# **AN ANALYSIS of the COMPARATIVE REVIEW of the FORESTRY ROUTE OPTIONS FOR INLAND RAIL via CECIL PLAINS**

*Prepared by Kevin Loveday, Pittsworth*

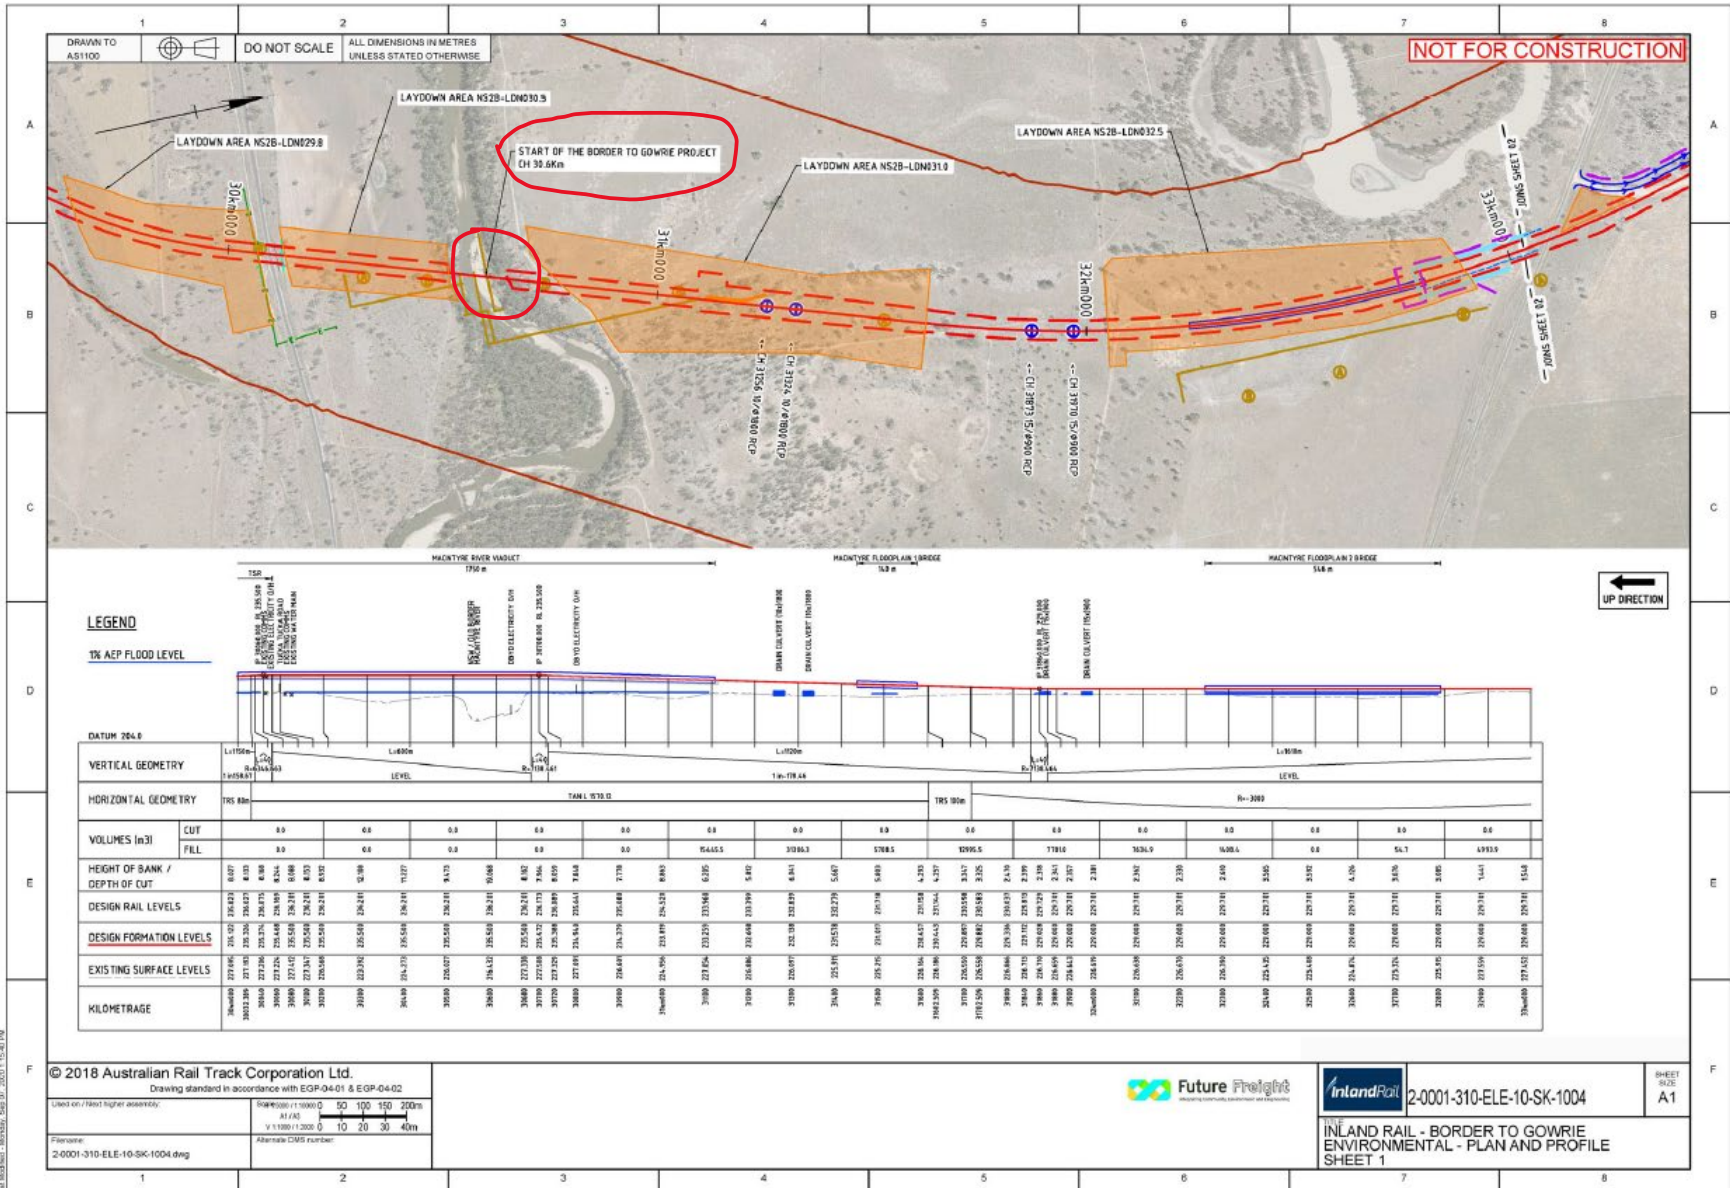
On page 7 - Chapter 2 APPROACH to this REVIEW Section 2.4, Table 2.3 summarises the basics of the different alignments (above). This table plainly states the LENGTH of each of the above options and clearly states that the Reference Design is **206.95 km** long. This essential data was supplied by ARTC in Appendix A (the ARTC Information Paper) which also states that the length is **206.9 km**.

However, in the **EIS of B2G**, ARTC have repeatedly stated many times that the length of the Reference Design is actually **216.2 km**. Chapter 5.5 of the B2G E.I.S. ( Project Description) states that "*The Project is a 216.2 km section ... between the NSW/Qld border and Gowrie*" and goes on to state that "*The Project commences at Chainage 30.6 km North Star to Border (NS2B) section at the NSW/Qld border - the medium point at the Macintyre River*". EIS Appendix ZZ, Sheet 1 confirms this by a clear notation indicating the start point of B2G.

However, the Chainage for the B2G does **not** start at this point on the river, as would be expected. The NS2B Chainage continues on into Queensland to finish at **39.85 km and this is where the B2G Chainage commences**. This is shown on Sheet 4 of EIS Appendix ZZ .

The fact is that there is a **9.25 km (39.85 - 30.6 km)** stretch of B2G route that is **NOT included** in ARTC's stated length of B2G Reference Design.

In reality, then, the actual length of B2G (the Reference Design route) is 206.95 **plus** 9.25 km. This, of course, equals **216.20 km - which is what the EIS states.**

So, in their Information Paper which underpins the Review by GTA, ARTC have **understated the actual length and supplied this data to GTA** - even though this distance was short by 9.25 km. **GTA have accepted this inaccurate data at face value and accordingly based most of their review on it.**

# Map D3: Forestry route via Cecil Plains – 1% AEP flood flux

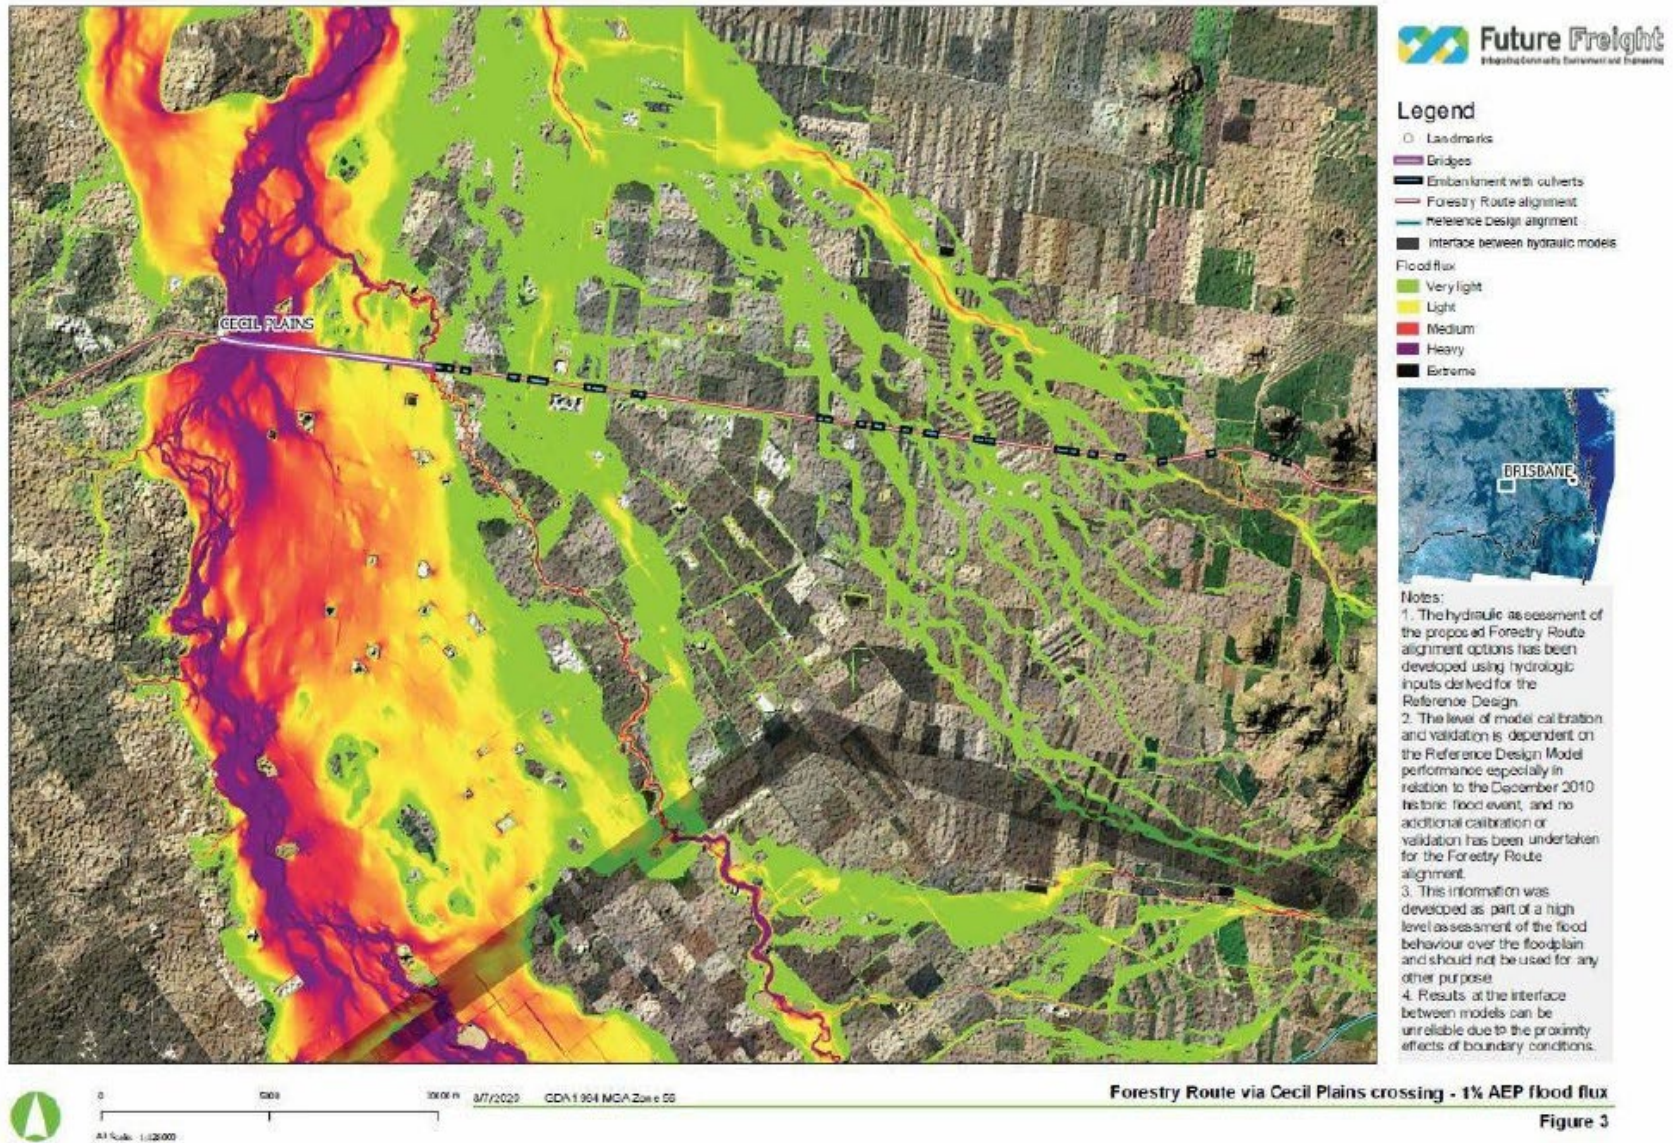
It is necessary, at this point, to mention that ARTC have made reference to their consultation with "locals" who "advised that collectively the two areas of floodplain are known colloquially as the "Condamine Valley floodplain"." And yet perusal of Map D3 (Page 42), which specifically shows the 1% AEP flood flux for the Condamine River east of Cecil Plains, shows that the extent of heavy and medium flooding only extends eastward from Cecil Plains for **3.1 km**. In fact, the crossroads at Horraine (3.6 km from Cecil Plains ) do not flood at all. Any North Branch water east of the Branch itself is marked as being "very light" flood risk.

So, it is puzzling to understand just why ARTC have referred to the 33 km section from Cecil Plains to Evanslea as being the "Condamine Valley floodplain". This nomenclature is obviously an exaggerated misnomer which has been used by ARTC to magnify the nature and actual width of the potential flood zone of Condamine River water. In fact, although the 20 km of country east of Nangwee is flat plainland to Evanslea, Condamine River water does NOT flow across this area at all.

Table 7.1 (page 21) states that ARTC have determined that a 6.3 km viaduct across the floodplain is required. Whilst acknowledging that viaducts will be necessary across both the main stream of the Condamine River and the North Branch, it is difficult to see why a continuous 6.3 km viaduct from Cecil Plains to the east side of the North Branch is essential - particularly in view of the fact that approximately 1 km of that distance is flood free at Horraine.

Why not 2 viaducts - one from Cecil Plains east for 3.1 km and another of 2.0 km over the North Branch? This proposal would bridge ALL the areas of potential heavy and medium flood flux as well as the 2 km area of light flood flux west of the North Branch and would save over a kilometre of unnecessary bridging cost impacting on the comparative costing of the Cecil Plains routes.

# ASRIS

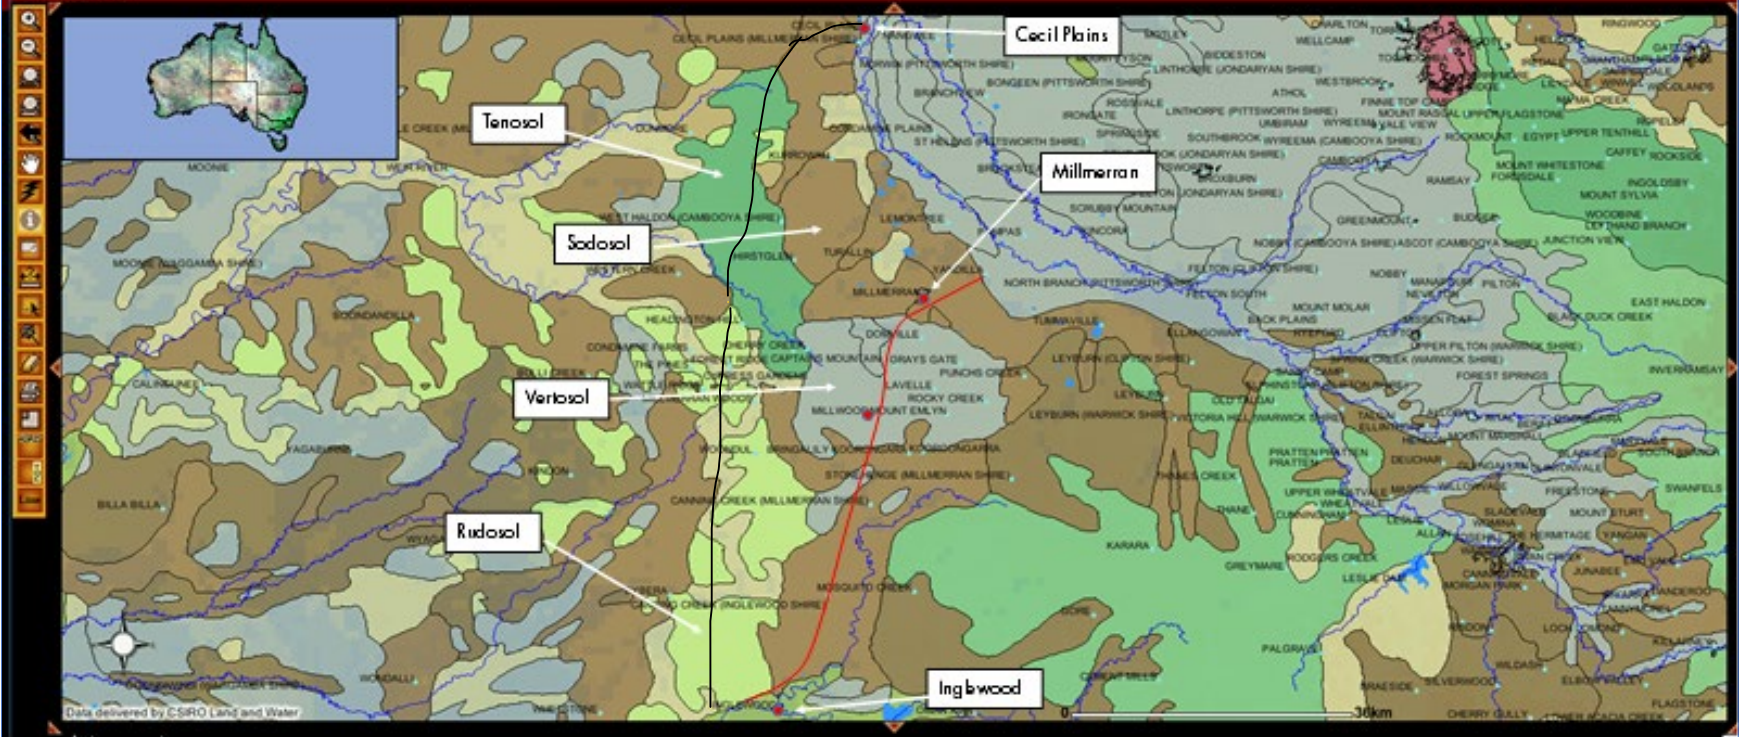
**B. Soil Types** ARTC have not included any analysis or research into the varying soil types and their respective characteristics along the alignments of the Reference and Cecil Plains routes. This exclusion from not only construction but also maintenance costs is difficult to understand given the absolute differences in suitability for rail projects and the resultant increases in costs (initial and ongoing) between differing soil types.

ARTC, on Page 11, have acknowledged that the 2 Cecil Plains routes use the same 90 km corridor between Whetstone and Cecil Plains and this alignment is 90 km long through state forest. Reference to ASRIS (Australian Soil Resource Information Systems) (see attached chart) indicates that this alignment passes primarily through RUDOSOL and TENOSOL soils. Their description is :-

A. RUDOSOL soils - Rocky, shallow soils (infertile, not very erodible, good foundation)

B. TENOSOL soils - Sandy, shallow soils ( infertile, not very erodible, good foundation).

The Reference Route, on the other hand, in the 75 km between Inglewood and Yandilla, traverses mainly SODOSOL and VERTOSOL soils. Their description is: -

C. SODOSOL soils - Duplex soils with sandy or loam A horizon overlaying a B horizon of sodic (dispersive, unstable) clay (very risky for foundation material due to high risk of tunnel erosion).

D. VERTOSOL soils - Cracking clays (fertile, highly erodible, poor foundations).

The soil type descriptions (above) clearly demonstrate the fundamental difference between the 2 different route alignments. The Cecil Plains routes follow country which is eminently suitable for heavy rail construction at base cost. The need for foundation excavation and fill with suitable material will be consequently eliminated as the soil itself lends itself to actual foundation usage.

The Reference Route, on the other hand, traverses land which is clearly unsuitable for the foundations for this rail track. Land along this corridor will have to be excavated to suitable depth and then filled and compacted with "bought-in" fill - just to have a stable base for the foundation, ballast, and track. The cost and logistic issues will be comprehensive. Where to stockpile and eventually dispose of the excavated material? Where to source suitable, compliant fill and how far to carry this fill to the required site? Where to source adequate and suitable water to properly compact the fill?
